MEMORANDUM
December 2, 2015

TO: Landmarks Board

SUBJECT: Public hearing and consideration of a Landmark Alteration Certificate application to demolish an existing house built in 1957 and, in its place, construct a new 2,500 sq. ft. house at 2110 4th Street in the Mapleton Hill Historic District, per section 9-11-18 of the Boulder Revised Code (HIS2015-00254).

Figure 14. Proposed Site Plan

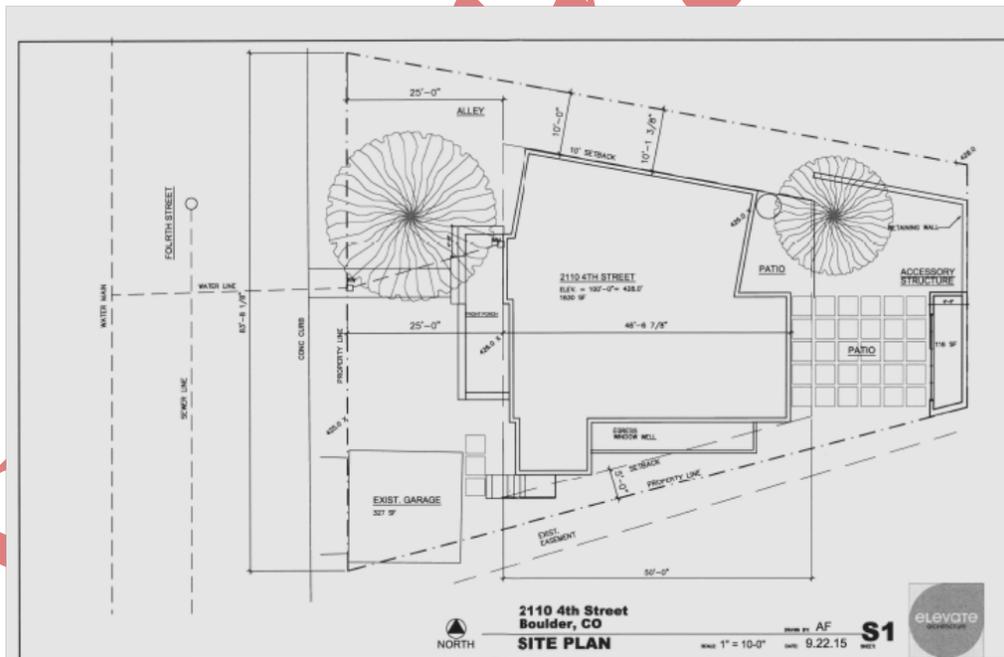
<i>General Design Guidelines</i>			
2.0 Site Design			
<p>Site design includes a variety of character-defining elements of our historic districts and building. Individual structures are located within a framework of streets and public spaces that set the context for the neighborhood. How structures occupy their site, in terms of alignment, orientation, and spacing, creates much of the context of the neighborhood.</p>			
	<i>Guideline</i>	<i>Analysis</i>	<i>Conforms?</i>
.1	<i>Locate structures within the range of alignments as seen traditionally in the area, maintaining traditional setbacks at the front, side and rear of the property</i>	<p>The property measures 67' wide, creating a shallow triangular shape where the typical building pattern in Mapleton Hill is 50' wide by 100' deep rectangular form. The building is proposed to have a similar front yard setback as the existing house, and is shown to be 11 ft. wider than the existing house and contained within the front, rear and side yard setback standards. This section of 4th Street in Mapleton Hill does contain a number of historic houses with alignments similar to that proposed. However, north portion of house at oblique angle to the rest of the house and not perpendicular to 4th Street as is historic pattern in Mapleton Hill. This condition will be visible from 4th Street and possibly Mountain View Drive. Redesign house to be</p>	No

parallel and perpendicular to 4 th Street.	
.2	<i>Building proportions should respect traditional patterns in the district</i>	The proposed house is comprised of three vertically-proportioned forms and one cubic form as viewed from the street. Truncated gable form as viewed from the northwest and multiple level flat roof forms appear inconsistent with historic character of the district. Traditional building proportions are typically simpler in form, not dominated by flat roofs and don't include oblique angles as shown (see .1 above). Roof of first story of south cubic form intersects with wall of upper stories of two north volumes on façade. Consider combining forms to reflect traditional building proportions more reflective of those historically found in the district and immediate streetscape.	No
.3	<i>Orient the primary building entrance to the street</i>	Primary entrance is oriented to the street.	Yes

<i>Guideline</i>	<i>Analysis</i>	<i>Conforms?</i>
.1	<i>Conform to Section 2.0 Site Design.</i>	See above for analysis.	No
.2	<i>Overall character of site is retained.</i>	Residential character will be retained, with similar setbacks. However multiple forms, truncated gable tower and oblique building angles at north will all be highly visible and alter character of the site in a manner that likely will	No

be incompatible with streetscape and southwest section of Mapleton Hill. Redesign building to better ensure that new construction be compatible with historic character of area (see section 2 above).	
.3	<i>Compatible with surrounding buildings in setback, orientation, spacing, and distance from adjacent buildings.</i>	Triangular lot configuration is anomalous to Mapleton Hill and presents design challenges. None-the-less, the proposed building retains similar setbacks, orientation, spacing and distance from adjacent buildings.	Yes
.4	<i>Proportion of built mass to open space not significantly different from contributing buildings.</i>	Proposed design preserves general proportion of built mass to open space.	Yes

Figure 16. Proposed north (side) elevation

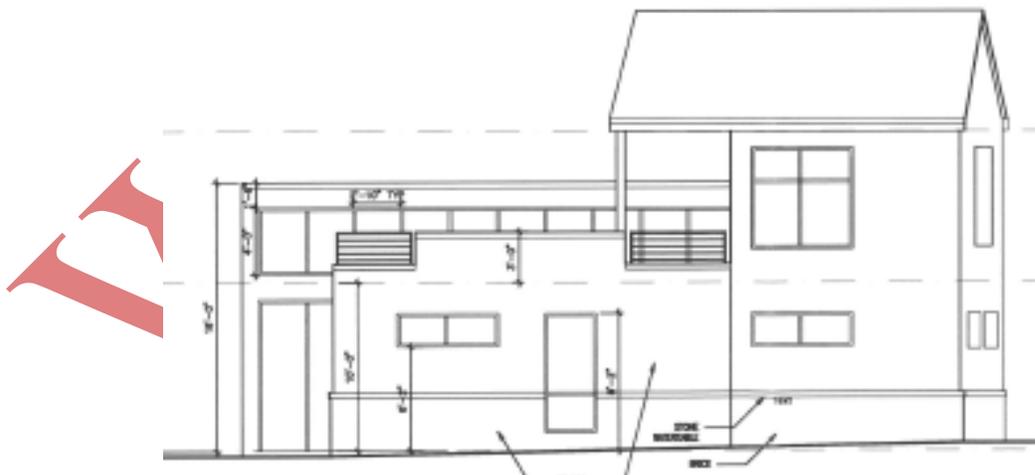
<i>Guideline</i>	<i>Analysis</i>	<i>Conforms?</i>
.1	<i>Compatible with surrounding buildings in terms of height, size, scale, massing, and proportions.</i>	Proposed scale is generally compatible with surrounding buildings. However massing and proportion with multiple forms and truncated gable and oblique building angles are inconsistent with surrounding historic building forms. Redesign to simplify mass and form to better reflect character of historic houses in the district.	No

.3	<i>New structures should use a roof form found in the district or on the landmark site</i>	While simple flat roof forms are occasionally found in the district, gable, hipped and gambrel roof forms are the pattern of historic buildings in the Mapleton Hill Historic District. Current design shows at least 3 different flat roof areas on the building. Redesign	No

Specifically, the multiple forms, truncated gable tower and oblique building angle at the north will all be highly visible and alter character of the site in a manner that will be incompatible with streetscape and southwest section of Mapleton Hill. The building form should be simplified to reflect the proportion of historic buildings of similar size found in the district. The window proportion, spacing and scale should be revised to reflect traditional patterns found in the district. Similarly, the material palette should be

revised to eliminate the metal roofing and oil copper fascia and proposed traditional roofing material and painted wood siding.

Proposed roof plan

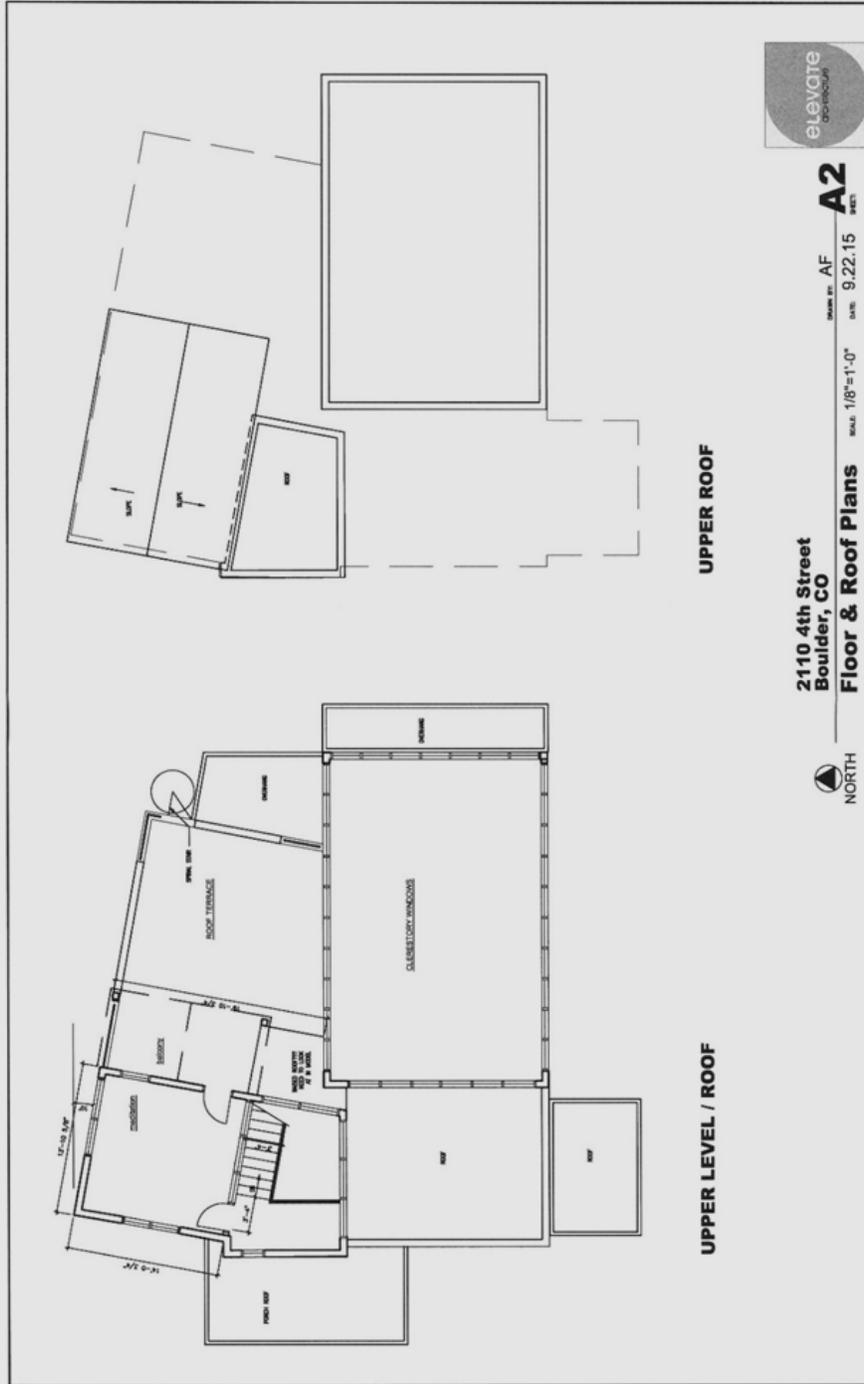
.7	<p><i>New construction should utilize a roof form found in the district.</i></p>	<p>While simple flat roof forms are occasionally found in the district, gable, hipped and gambrel roof forms are the pattern of historic buildings in the Mapleton Hill Historic District. Current design</p>	No

shows at least 4 different flat roof areas on the building. Redesign house to simpler roof design that is more reflective of roof forms on like sized historic houses in Mapleton Hill.	
.8	<i>Use building materials that are familiar in their dimensions and that can be repeated. This helps to establish a sense of scale for new buildings. Whenever possible, use familiar building components in traditional sizes. Avoid large featureless surfaces.</i>	Proposed materials include brick, stone, stained vertical wood siding and a standing seam metal roof and oiled copper fascia. Little historic precedent for use of metal roofing or stained wood siding in Mapleton Hill. , and likewise revise design to simplify material palette including roofing and more tradition painted wood siding. Provide detailed information on all materials including proposed path ways, patio and retaining walls.	No

Proposed East and West Elevations

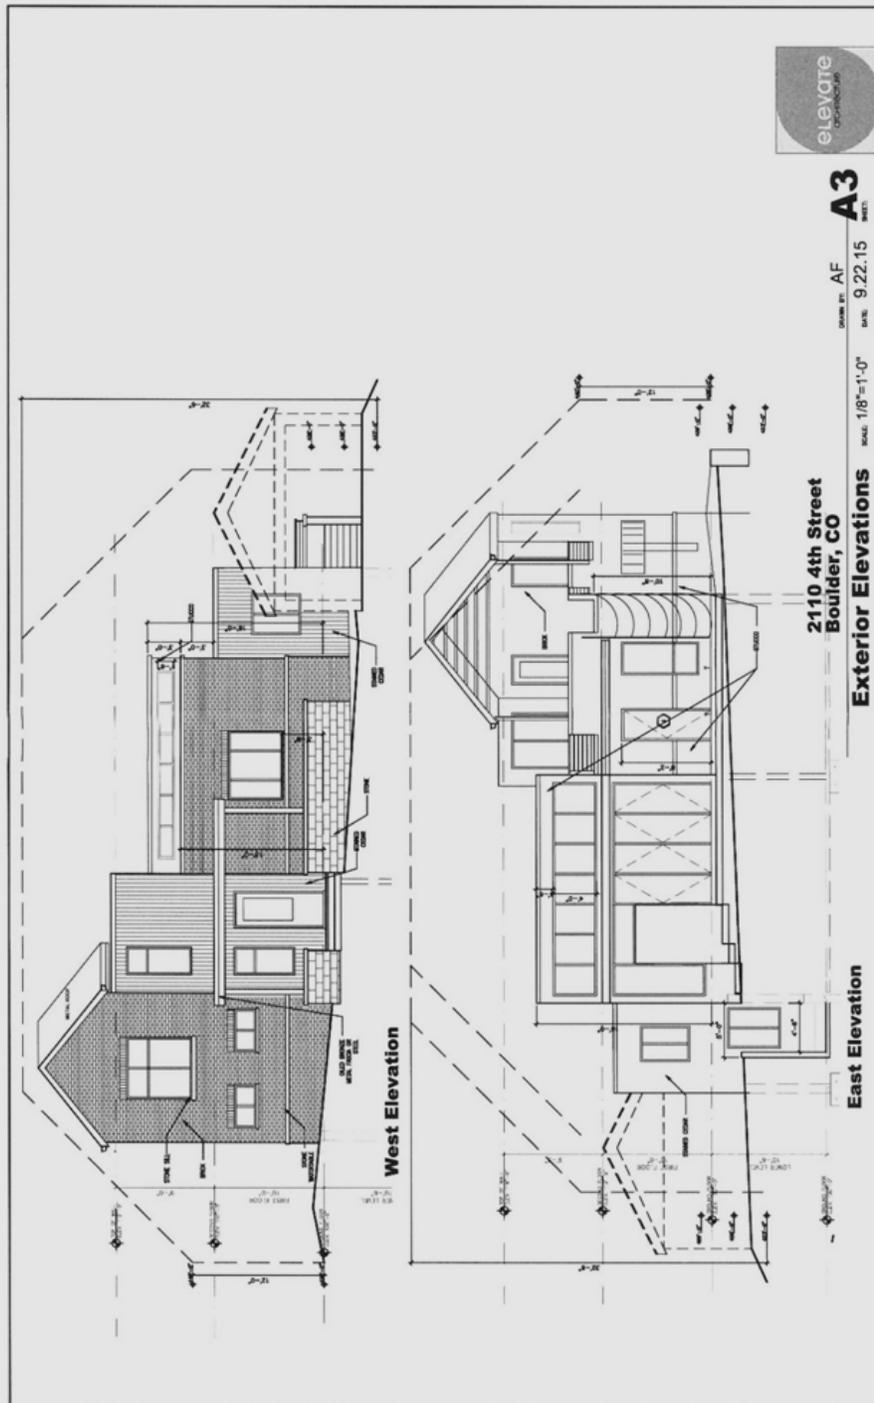
house to simpler roof design that is more reflective of roof forms on like sized historic houses in Mapleton Hill.	
.4	<i>Porches should be compatible in massing and details to historic porches in the district, and should be appropriate to the style of the house.</i>	Consider redesign to provide for full-porch area taking cues from historic houses in the district. Alternatively, consider reducing the size of the patio to reflect the overhang of the porch roof.	Maybe
.5	<i>Dormers should be secondary to the main roof and should be lower than the roofline. Oversized dormers are inappropriate.</i>	Dormers are not proposed.	N/A
